Access Compliance Report

Public Rights-of-Way

Intersection ID: 46816	Main Street: CYPRESS_VIEW_DR	Cross Street: ARBOR_VISTA_DR	Location: SW
ADA ID: 91448AF3B22E	Ramp Type: Perp	Initial Pass/Fail: Fail	Overall Compliance: No
Severity Score: 21.25			
Codes/Mitigation Info/Possible Solution		Field Measurements/Component Compliance

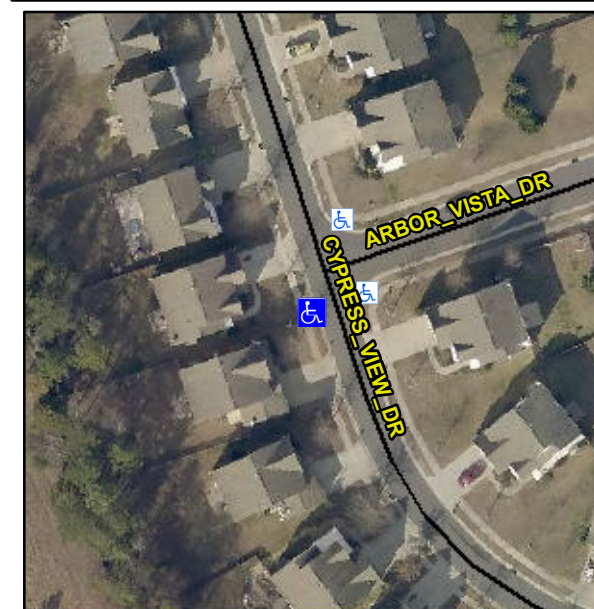
Not Found, R304.5.1, R304.2.2

Compliance	Description	Data	Compliance	Description	Data
N/A	Ramp Length (in)	47.0	No	Ramp Slope (%)	8.6
No	Ramp Width (in)	46.5	Yes	Ramp XSlope (%)	2.0
N/A	Flare Type LT	N/A	N/A	Flare Type RT	N/A
N/A	Flare Slope LT (%)	N/A	N/A	Flare Slope RT (%)	N/A
N/A	Flare Traversable LT?	N/A	N/A	Flare Traversable RT?	N/A
N/A	Landing Length (in)	N/A	N/A	DWS Provided?	N/A
N/A	Landing Width (in)	N/A	N/A	DWS Contrast?	N/A
N/A	Landing Slope (%)	N/A	N/A	DWS Length (in)	N/A
N/A	Landing X Slope (%)	N/A	N/A	DWS Full Width?	N/A
N/A	Landing Curb? (Y/N)	N/A	N/A	DWS Offset (in)	N/A
N/A	Shared Landing?	N/A			
N/A	Gutter Ponding?	N/A	N/A	Gutter Slope (%)	N/A
N/A	Gutter Lip Ht (in)	N/A	N/A	Gutter X Slope (%)	N/A
N/A	Painted X Walk1?	No	N/A	Painted X Walk2?	N/A
	X Walk 1 Direction	To E		X Walk 2 Direction	N/A
N/A	X Walk 1 Width (in)	N/A	N/A	X Walk 2 Width (in)	N/A
	X Walk 1 Slope (%)	2.6		X Walk 2 Slope (%)	N/A
	X Walk 1 X Slope (%)	2.7		X Walk 2 X Slope (%)	N/A

Remove & Replace Entire Ramp.
